PROJECT **27 Downside Crescent
 London
 NW3 2AN**

ISSUE MINOR AMENDMENT APPLICATION
 TITLE **Proposed Elevations**

JOB	DRAWING	REV
009	PL05	C

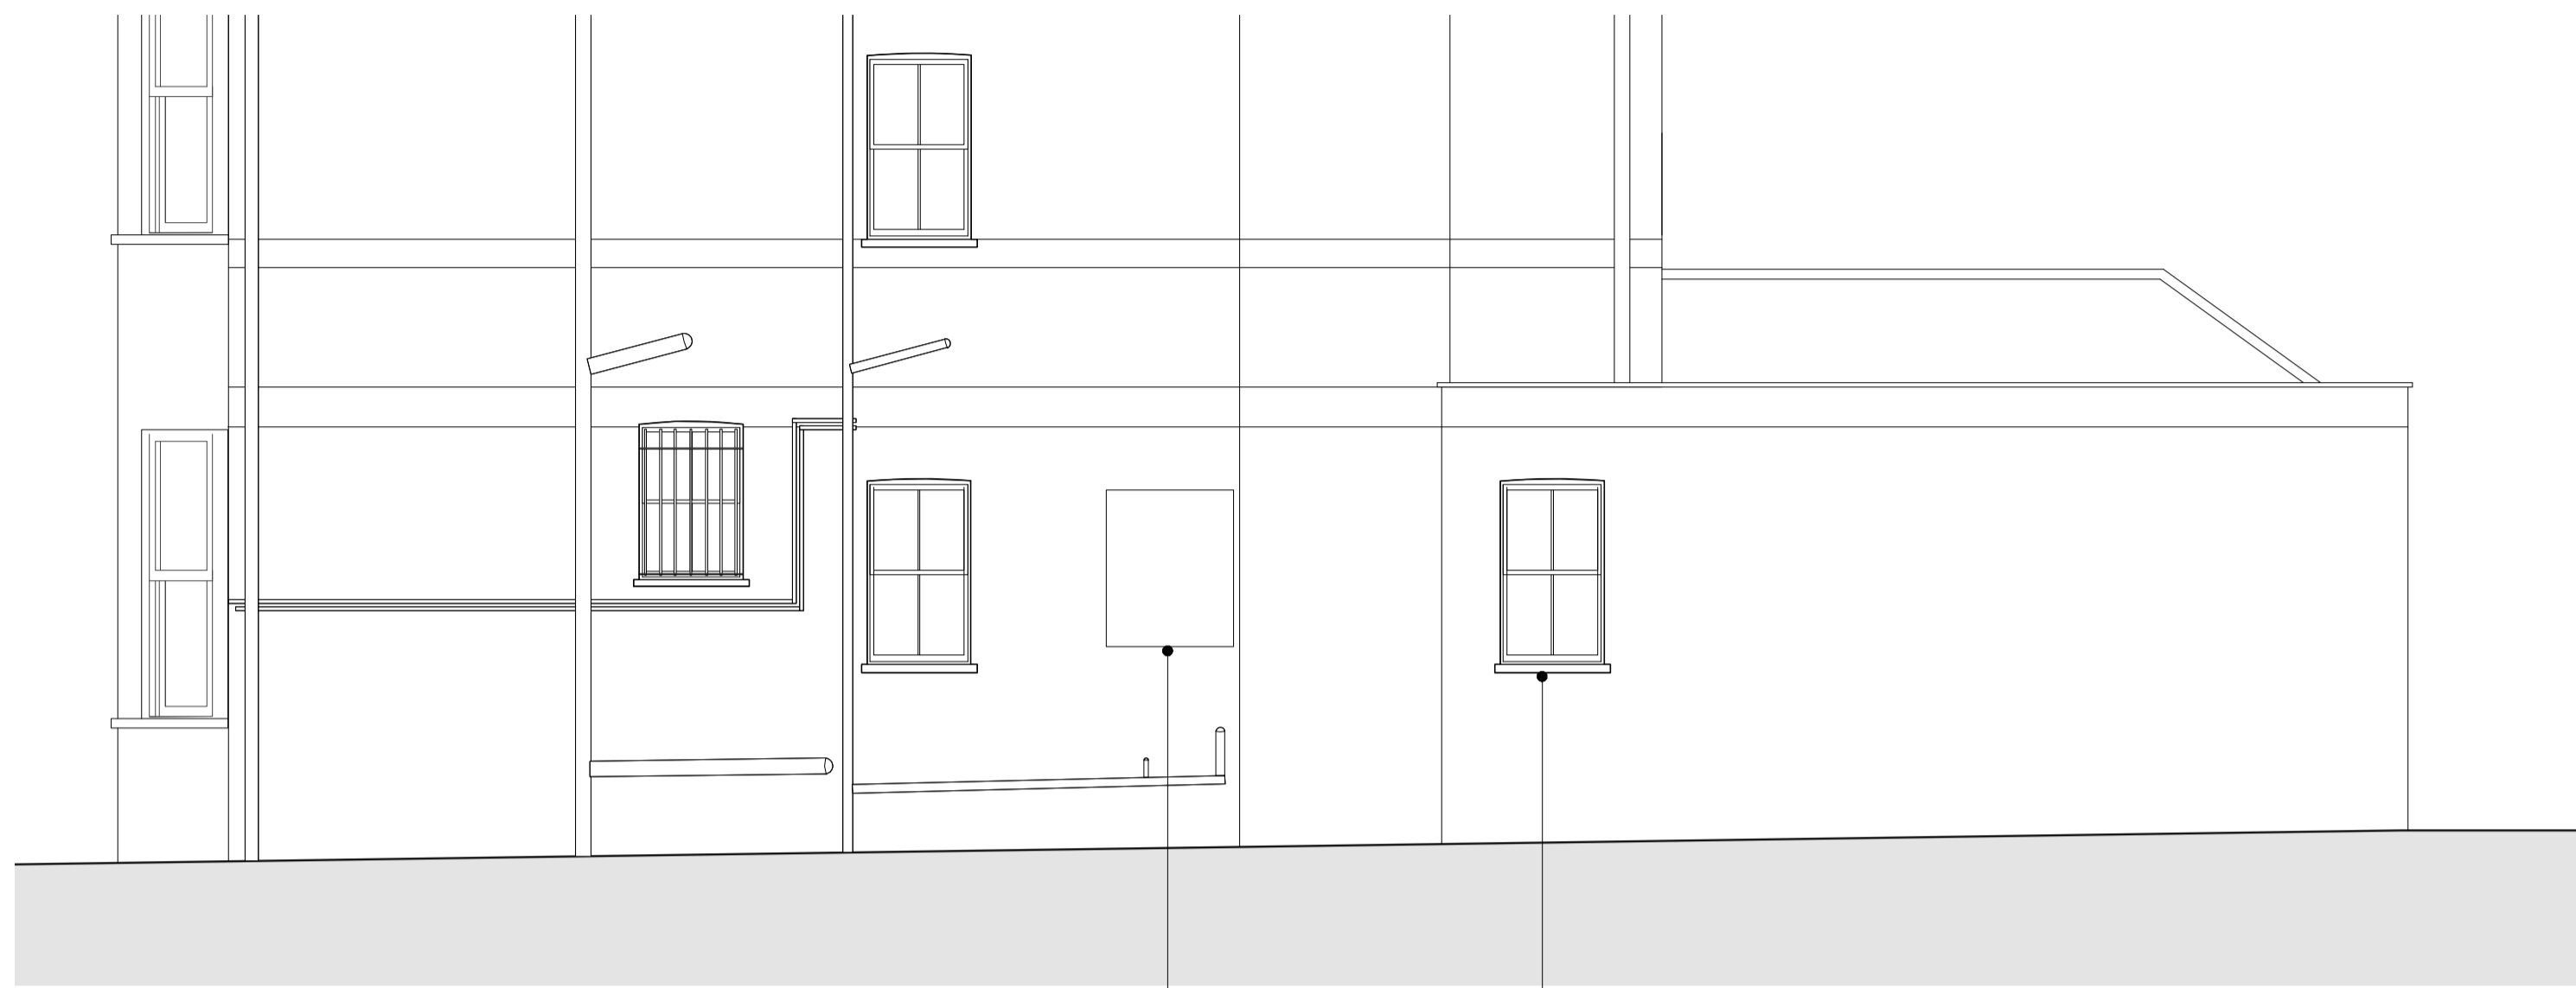
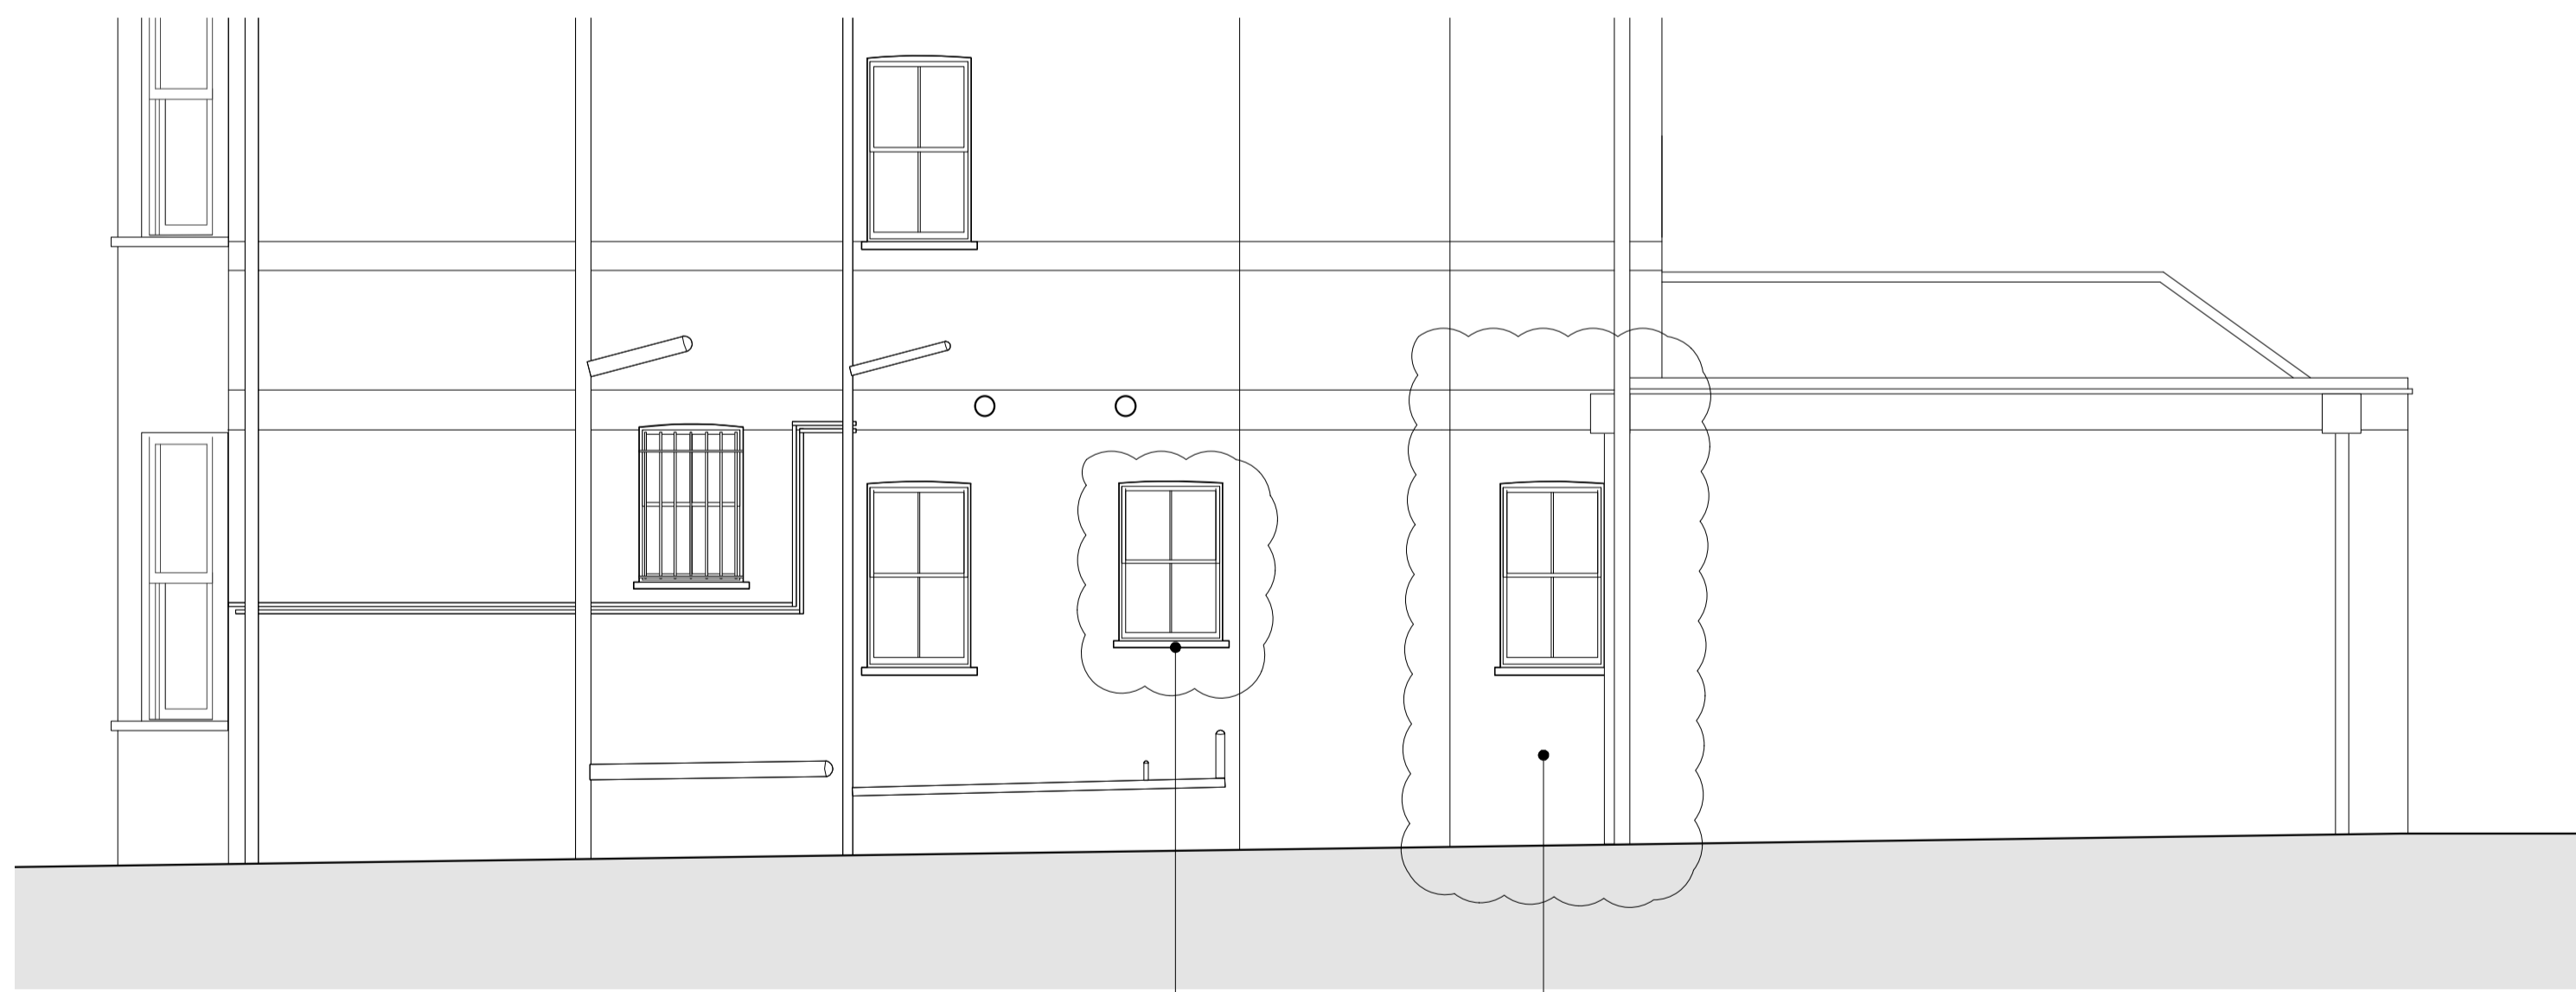
Reduced sized rooflight

No side extension
 New timber framed sash window to replace existing aluminium framed window

Timber framed windows and doors
